Testimony of Dr. Sam Blakeslee to the U.S.
Senate Committee on Environment and
Public Works (December 3, 2014)

WRITTEN STATEMENT

EXECUTIVE SUMMARY

Figure 10. Comparison of Individual 84th Percentile Ground Motion Prediction Equations with Best Estimate Parameters and Diablo Canyon Review Spectrum

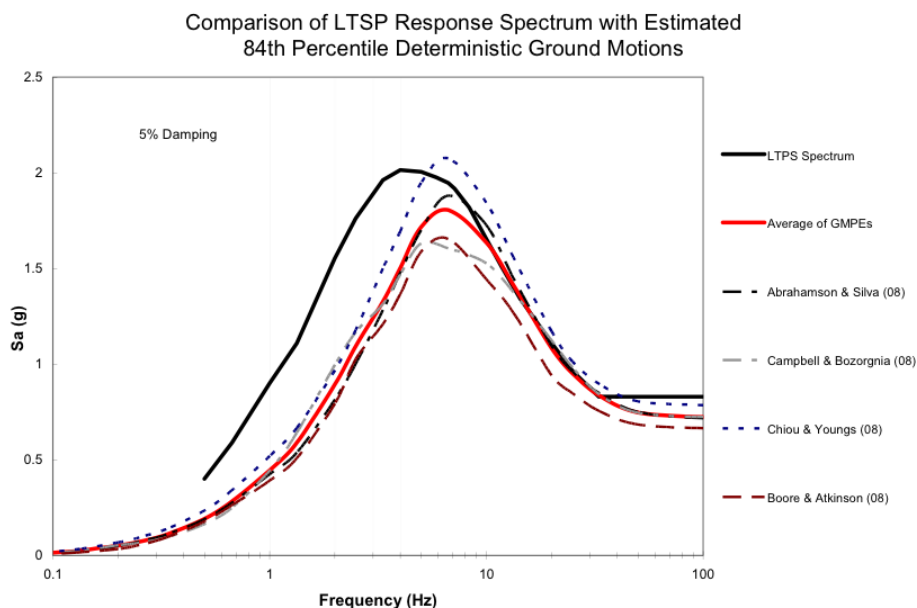
The five NGA GMPEs which, when averaged, produce GMPE-3 are each shown in figure 10 from the NRC report. The NRC staff analysis also tested the significance of using the lower-bound estimate of rock velocity rather than the “best estimate” (lower velocity corresponds to higher shaking). Using a rock velocity of 800 m/s instead of 1,100 m/s resulted in a spectrum that, “exceeds the LTSP spectrum by a small amount over some frequencies.” In summary, by using reasonable but somewhat more conservative approaches to the three available variables (the NGA model selection, earthquake magnitude estimate, or rock

velocity) the spectrum was found to be “very close” or “exceeds...by a small amount.” This result was quite significant because it showed that, even in the early days when the Shoreline Fault was still believed to be relatively small, shaking could exceed the LTSP Spectrum assuming certain models and certain rock parameters. The Chiou & Youngs (08) GMPE (dotted blue line) exceeds the LTSP Spectrum (solid black line) at about 7 Hz and above, the others are just a little below, hence the characterization that they are “*very close*” (emphasis added).

This result naturally raises important questions about the effect of the new GMPE applied to the Shoreline. For example: would estimation of shaking on a 24 km rupture of the Shoreline Fault have exceeded the LTSP if GMPE-1 was used rather than GMPE-3? Given what is shown in Figure 10 it appears that the answer would likely be “yes” if the difference between GMPE-3 vs GMPE-1 was anything other than de minimis, but that analysis was not performed in the 2009 Shoreline report.

Figure 3: Shakal et. al., 2004 showing remarkably high and low accelerations in the extreme near-field (rupture started where the star is shown and then propagated to the north-east and south-west where they stopped)

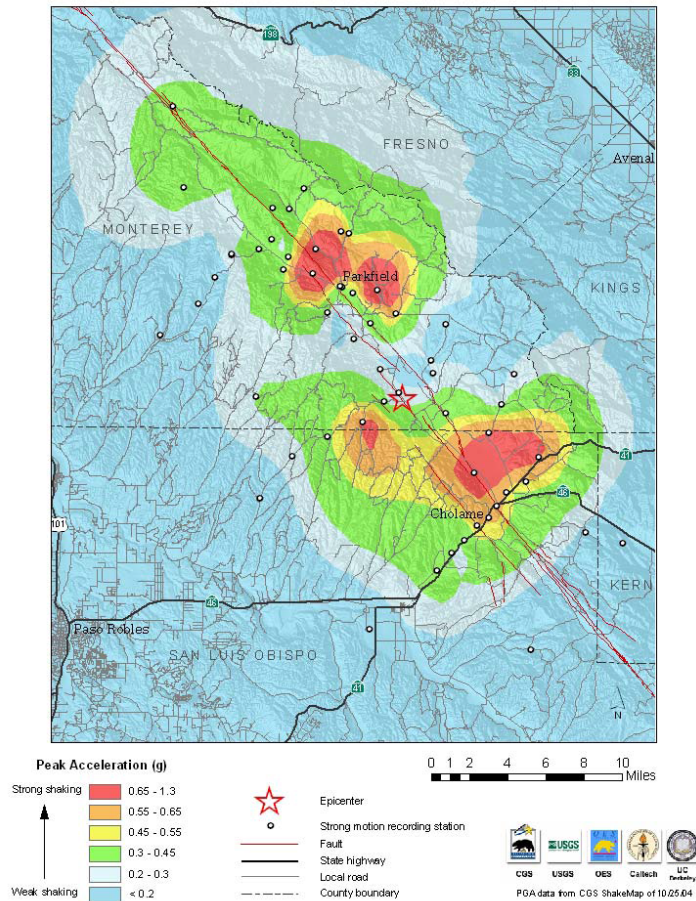
For example, in 2004, 48 strong-motion recordings within 10 km of the San Andreas Fault were made of the M6.0 Parkfield earthquake^{xii}. This dataset was used to test three different attenuation-distance equations. These equations are shown to do a good job of making accurate predictions for distances beyond about 10 km, but the observed shaking becomes highly variable in close proximity to the fault. Rather than finding accurate predictions of mean shaking in the extreme near-field the paper notes,

“Peak ground acceleration in the near-fault region ranges from 0.13 g at Fault Zone 4, to 1.31 g at Fault Zone 14, ten times larger, to over 2.5 g at Fault Zone 16 (where the motion exceeded the instrument capacity and the actual maximum value is still being estimated).”

The dense strong-motion Parkfield recordings are relevant to the conclusions of the Report for a number of reasons.

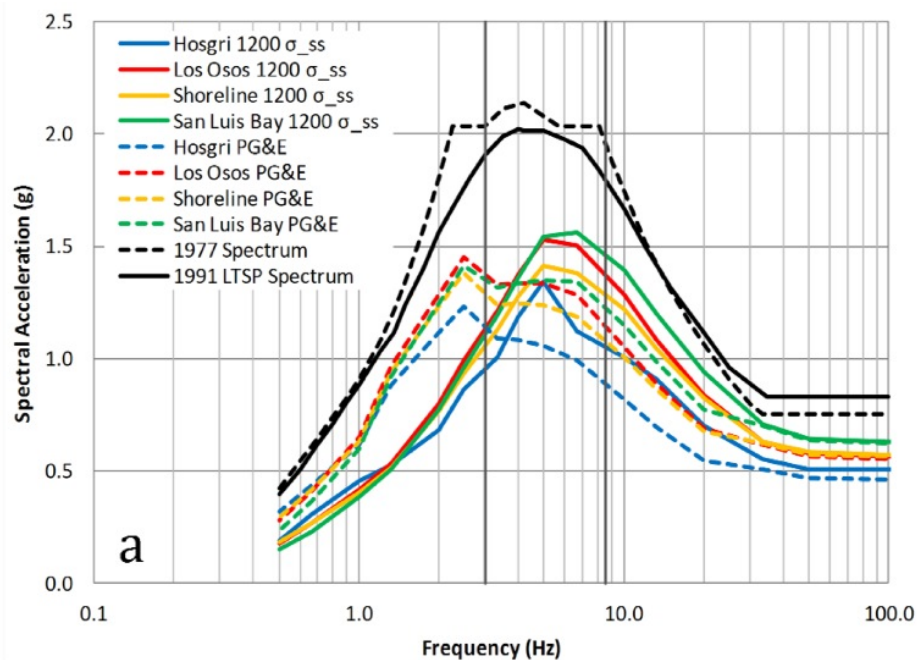
As seen in Figure 7a from the Independent Peer Review Panel (IPRP) report and in a number of other related reports, the new less-conservative equations cause a major reduction in shaking across the entirety of the frequency spectrum from a hypothetical earthquake on the Hosgri fault (compare blue lines which use the newly devised methods with black lines which use the prior methods, in figure 7a above). In the frequency range from 2-10 Hz the less-conservative methodologies have cut the maximum estimated acceleration from 2 g down to about 1.3 g. At the peak-frequency range, from 30-100 hz, the maximum estimated acceleration as been reduced by a third from .75 g to under .50 g. In fact the de-amplification effect is even larger than this comparison suggests because the blue lines, which represent the shaking on the re-interpreted Hosgri, assume a larger rupture on the Hosgri Fault than the earthquake that was used to initially create the 1977 HE basis exception.

More importantly, as can be seen in Figure 7a the shaking from the Los Osos, Shoreline, San Luis Bay Faults all exceed the re-interpreted Hosgri (red, yellow, green lines are all above the blue line). **One can reasonably conclude that, if the original analytical methods had been used to estimate ground motion, the new seismic threats would exceed the original HE and LTSP spectra.**

Figure 7. Continued.

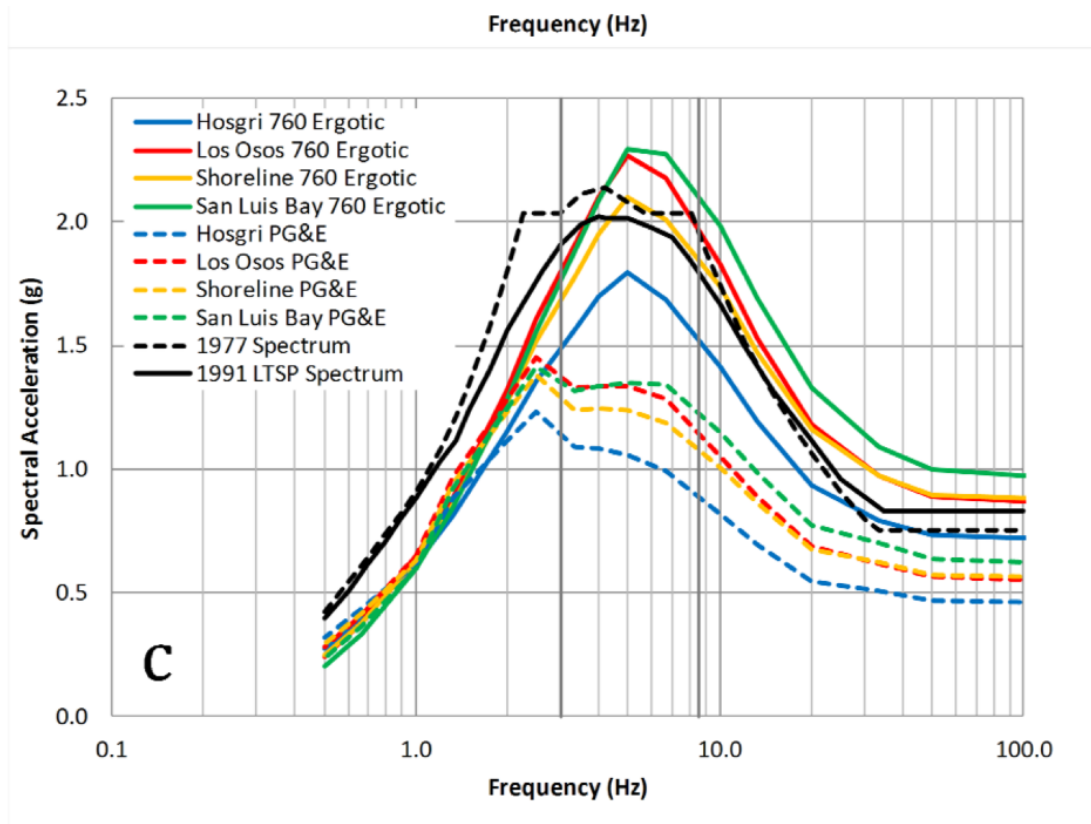
“These two figures also show that if DCPD site had a Vs30 value of 760 m/s rather than 1,200 m/s, and if the site behaves more like an average site in ground motion amplification, **some deterministic spectra would exceed the 1991 LTSP spectrum^{xiii}**” (figure 7c below).

In fact, it is more than just “some.” Under the scenario shown in Figure 7c the IPRP shows that the LTSP/HE spectrum is exceeded by **all** of the newly discovered and re-interpreted seismic threats, including earthquakes on the Shoreline Fault, the Los Osos Fault, and the San Luis Bay Fault (note that the red, yellow, and green lines are all above the solid black line). The fourth and largest hypothetical earthquake scenario, a M7.3 rupture on a joint Hosgri/Shoreline Fault, is not shown on this figure but could reasonably be assumed to exceed the LTSP/HE as well.

This sensitivity analysis shows that the cumulative effect of less-conservative fast rock velocities along with less-conservative GMPEs is clearly not a small issue, nor is it a only an academic issue. The IPRP reviewed the limited wellbore data (see IPRP Report 6 Figure 4) and concluded that the wellbore velocities appeared to be lower than those estimated by PG&E, which could result in the conclusion that PG&E has underestimated shaking from new seismic threats even if the new equations are allowed. The IPRP challenged PG&E's use of wellbore data at the ISFSI site to justify the higher 1,200 m/s velocity and instead focused on the velocities measured in the wellbore data closest to the facility.

Figure 4. Shear wave velocity profiles from 1978 downhole velocity surveys (provided by PG&E).

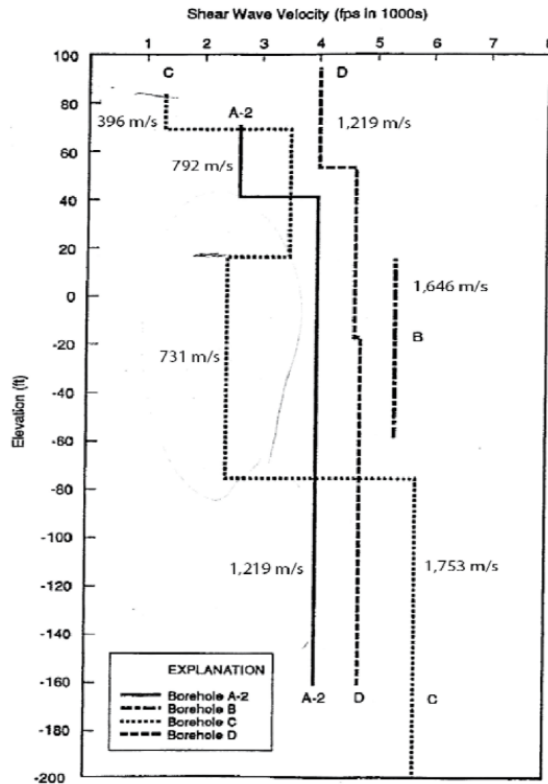
"Consider the three usable measured profiles, A-2, C, and D, the mean value at 10 m is approximately 800m/s, considerably below PG&E's mean of 1200m/s." and "If A-2 had the same velocity as C at a depth of 5m, consistent with the relative weathering described in the borehole logs, the mean velocity at that depth would be about 650m/s, also below PG&E's mean value of 1000m/s."

Second, even if one were to accept the use of GMPE-4, which is problematic for the reasons previously stated, the critically important rock velocities upon which the de-amplification factors are based are complex, in dispute, and arguably lower than those used by PG&E, which would mean that shaking would be significantly larger than stated in the Report. Indeed, a conservative approach toward this technical question would have used of the lowest velocities found in the well data rather than the highest.
